**Monks Orchard Residents'
Association
Planning**

Reference:	21/04094/FUL
Application Received:	Tue 03 Aug 2021
Application Validated:	Tue 03 Aug 2021
Address:	27 Orchard Rise Croydon CR0 7QZ
Proposal:	Demolition of an existing house and erection of two semi-detached pairs to provide 4 houses including associated amenity space, landscaping, parking, cycle and refuse storage.
Status:	Awaiting decision
Case Officer:	Nathan Pearce
Consultation Date:	Wed 08 Sep 2021
Decision Deadline:	Tue 28 Sep 2021

Please accept this letter as a formal objection to Application **Ref: 21/04094/FUL** for **Demolition of an existing Bungalow and erection of two semi-detached pairs to provide 4 houses including associated amenity space, landscaping, parking, cycle and refuse storage.**

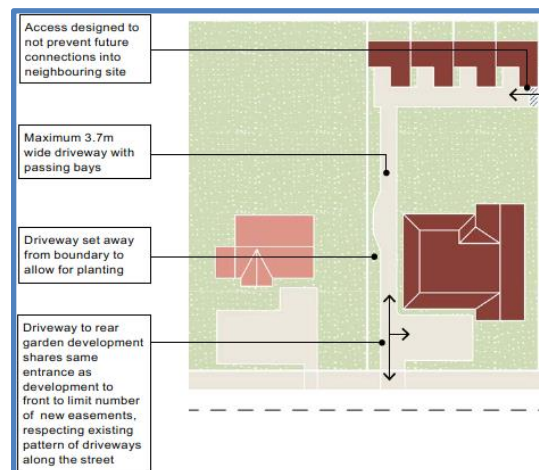
- 3.6.1 The Bin Storage for each dwelling is positioned adjacent to the front entrances and only has space to accommodate two Bins whereas the current requirement for Croydon Refuse Collection requires a minimum of three bins and four if Garden Waste is included. There is therefore **insufficient** bin storage capacity for each dwelling.

The Bin Store for collection from all dwellings is on the forecourt in front of the building line of the development and therefore in breach of DM13.1.

3.6.2 The access for the **Cycle Stores** requires lifting and transporting the bicycles through the interior of the dwellings as the provided drawings show fencing (without gates) preventing access to the Cycle Stores in the rear gardens via the flank sides of each of the dwellings.

3.6.3 The length of the Driveway is **≈42m** from Orchard Rise footpath to site, which exceeds the Bin '**Pull Distance**' of **20m** for Refuse Collection operatives, from a Collection Vehicle parked in Orchard Rise. It is unlikely that the Refuse Collection Vehicle would enter the driveway to get nearer the Bin Store collection point as there is no viable turning head and the vehicle would need to reverse out over the footpath. Also, the angle of entry would likely prevent the refuse collection vehicle a straight entrance into the driveway from the narrow **5m** width Orchard Rise roadway.

3.6.4 The requirement of **DM13.1** has been **breached** as the refuse and recycling facilities (Bin collection Stores) for the proposed development are positioned on the forecourt and are visually intrusive and compromise the provision of shared amenity space and parking access.

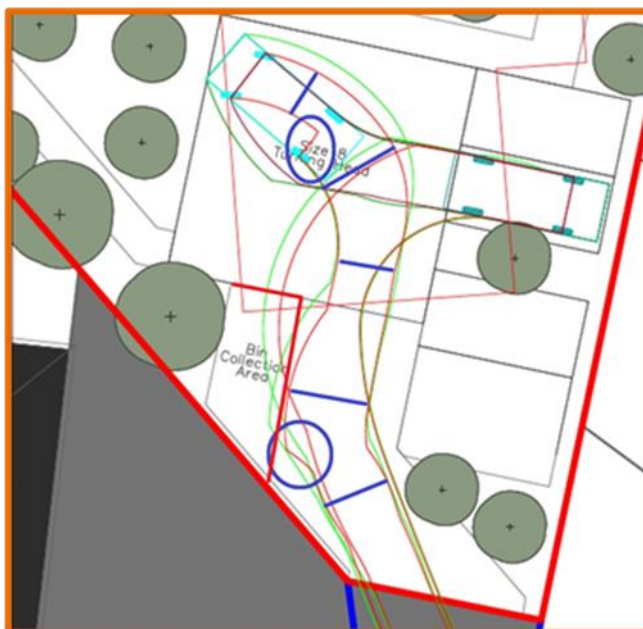
9.2.1 The Swept path diagram for Parking Bay 1, is extremely suspect. The Swept paths show an occurrence where the vehicle moves sideways at a steering 90° lock, or one wheel moves sideways (one occasion) but the adjacent wheel remains on a smooth trajectory which is again

physically impossible (shown circled Blue on the illustration). In addition, the Wheelbase width is illustrated as variable over the swept path, which again is impossible. It is concluded that this Swept Path Diagram has been incorrectly produced to give the impression of acceptable ingress and egress, but the reality is an impossible manoeuvre and is **unacceptable**.

9.2.2 The manoeuvre also fails the Refuse Bin Collection area which is approximately 3m from the end of bay 4 (disabled bay).

9.2.3 Bay 1 should be the Disabled Bay to be nearest to Flat 4 which is to M4(3) Wheelchair user accommodation Building Regulation standard.

Parking Bay 2

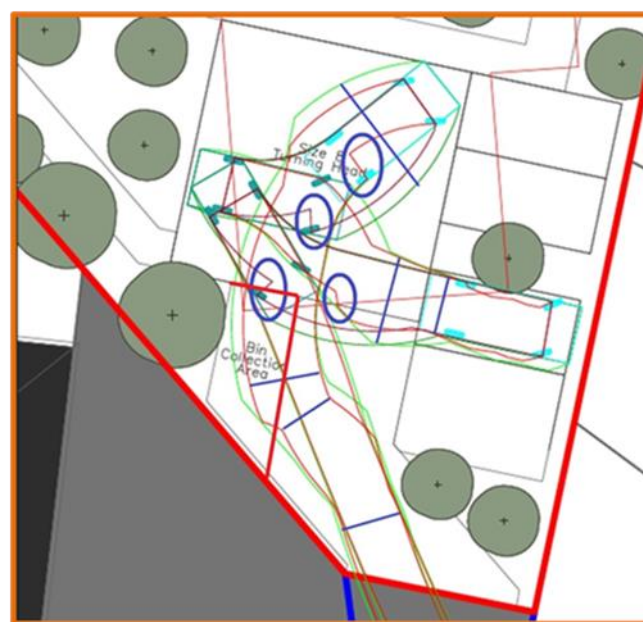
9.2.4 The Swept path diagram for Parking Bay 2, again is extremely suspect. The Swept paths again show occurrences where the vehicle moves sideways at a steering 90° lock, or one wheel moves sideways but, the adjacent wheel remains on a smooth trajectory which is physically impossible (shown circled Blue on the illustration right). In addition, the Wheelbase width is illustrated as variable over the swept path, which again is impossible. It is concluded that this Swept Path Diagram has also been incorrectly produced to give the impression of acceptable ingress and egress, but the reality is an impossible manoeuvre and is **unacceptable**. The manoeuvre also fails the Refuse Bin Collection area.

Parking Bay 4 (Disabled Bay)

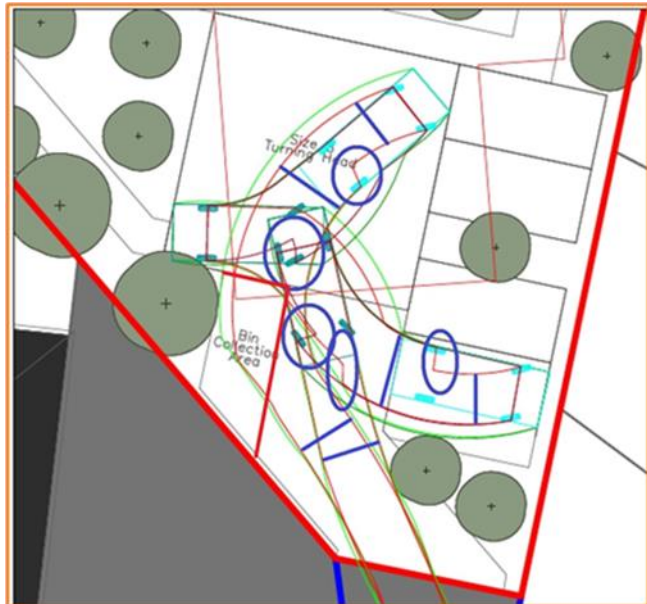
9.2.6 The Swept path diagram for Parking Bay 4 (Disabled Bay)

is again, extremely suspect. Bay 4 for the disabled driver has impossible ingress and egress due to the proximity of the Bin Collection Area. The Swept paths show a number of occurrences where the vehicle moves sideways at a 90° steering lock, or one wheel moves sideways but the adjacent wheel remains on a smooth trajectory which is physically impossible (shown circled Blue on the illustration right). This occurs on at least 5 occasions for this Disabled

Bay 4. In addition, the Wheelbase width is illustrated as variable over the swept path, which again is impossible. It is concluded again that this Swept Path Diagram has been incorrectly produced to give the impression of acceptable ingress and egress, but the reality is an impossible manoeuvre and is **unacceptable**. The manoeuvre also fails the Refuse Bin Collection area.
